CERTIFICATE OF APPROPRIATENESS

Property: 417 Highland Street, Lot 12, Tract 13A, Block 16, Woodland Heights Neighborhood Subdivision. 1,648 SF, one-story wood house on a 7,500 square foot (75' x 100') interior lot.

- Relocate historic structure 11' 7" to the East on the lot maintaining 20' building line front setback
- Restore original siding underneath synthetic siding
- Construct a 2-story rear addition with an attached garage
 - First floor 436 sq. ft.
 - Second floor 1,463 sq. ft.
 - Garage 500 sq. ft.
 - Screened porch 180 sq. ft.
- Mix of fixed and DH, inset & recessed, wood windows
- Max ridge height of 27'
- Composition shingles with a 4:12 roof pitch
- Reveal smooth cedar clapboard to match existing structure's siding

Recommendation: Approval

Figure 3 - Existing Roof-Right Rear Portion Appears to be Non-Original

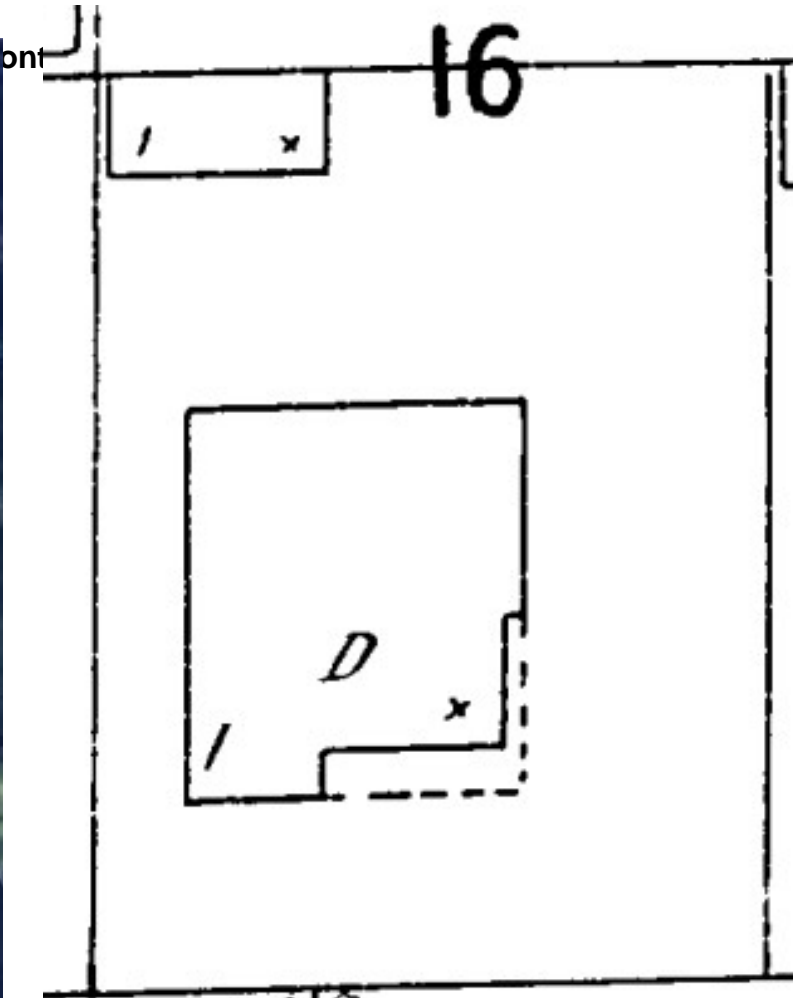
Figure 1 - Right Rear of House Non-Original Addition

EXISTING EAST ELEVATION

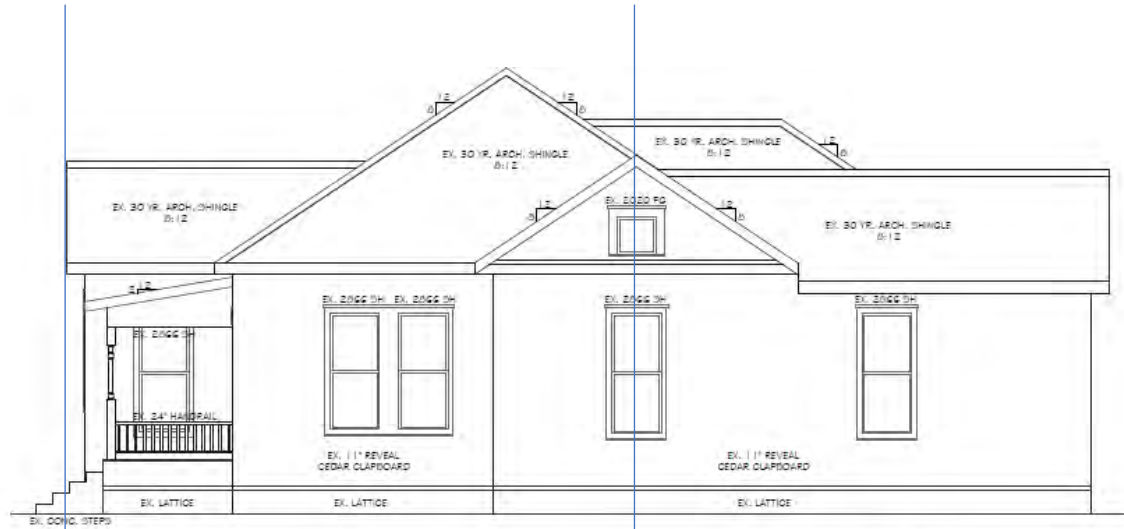
This original right rear corner is re-revealed
